# 1968 Corvette: Service Bulletin: Heat Damage to Engine Wiring Harness at Starter Solenoid

**Source:** Chevrolet Dealer Service Technical Bulletin

**Bulletin No:** 68-T-66

**Date:** October 30, 1968

Figure 1

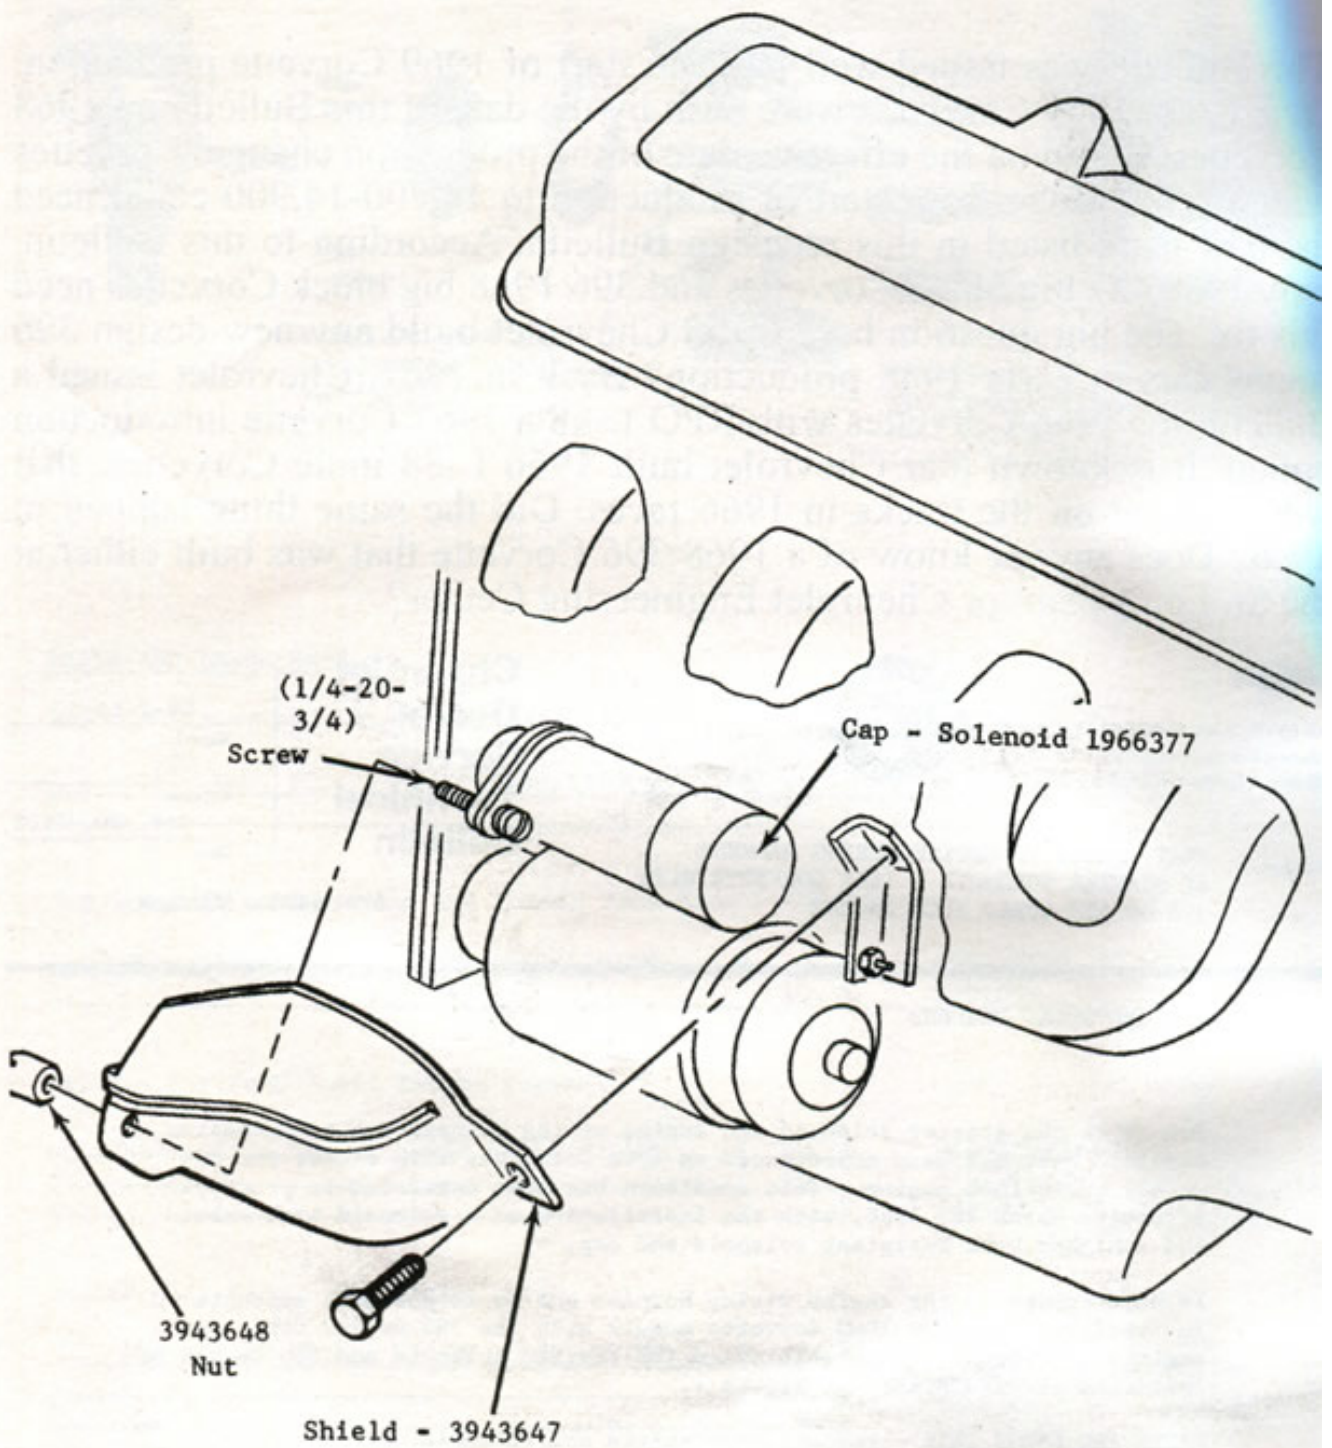
Damage to the starter solenoid and engine wiring harness due to excessive manifold heat has been experienced on 1968 Corvettes with either the 396 or 427 cubic inch engine. This condition has been corrected in production effective March 28, 1968, with the installation of a solenoid heat shield and a higher heat resistant solenoid end cap.

If heat damage to the engine wiring harness and/or solenoid is encountered in the field on early 1968 Corvette models with the 396 or 427 cubic inch engine, the solenoid heat shield and the revised solenoid end cap should be installed as illustrated in figure 1.

<b>QUA.</b>	<b>PART NO.</b>	<b>PART DESCRIPTION</b>
1.	1	3943647	Shield
2.	1	1966377	Solenoid Cap
3.	1	3943648	Special Nut

Installation of Heat Shield  
and Solenoid Cap
